Determination 2008/68

Provision of an access stair in a proposed multistorey serviced apartment / hotel building at 51-53 Albert Street, Auckland

Figure 1: Diagrammatic section though the building

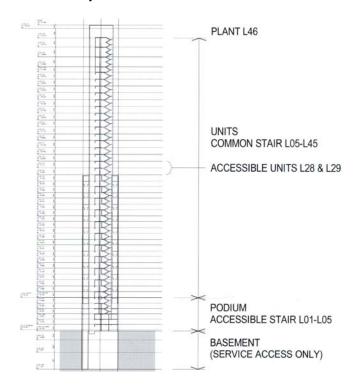
- 2.1 The proposed building shown diagrammatically in Figure 1. It is 134 metres high, between the entry and top floor levels, and contains:
 - a three-level basement
 - a podium with four main levels and a mezzanine
 - a tower with 41 levels, 38 of which contain one or two-bedroom units and 3 of which at levels 43 to 45, contain penthouse apartments
 - two accessible apartments on each of levels 28 and 29.
- 2.2 The proposed building has an accessible stair up to level 5 and two sets of "common stairs" for the reminder of the building. All levels are to be serviced by two high-speed lifts that have facilities for persons with disabilities, together with emergency power and lighting systems. All doors within the tower core will be electronically security controlled.

- 7.1.1 In summary, the applicant has submitted that an accessible stair is not required above level 5 of the building because:
 - all levels are serviced by high speed lifts with provisions for persons with disabilities

- all doors within the tower core will be security controlled
 - the height of the building would ensure that the lifts rather than the stairs would be used by all staff and guests, irrespective whether such persons are ambulant or disabled.

8.1 In accordance with section 188 I hereby determine that the building requires an accessible stair to service all floors of the projected building in order for it to comply with the requirements of Clause D1 of the Building Code.
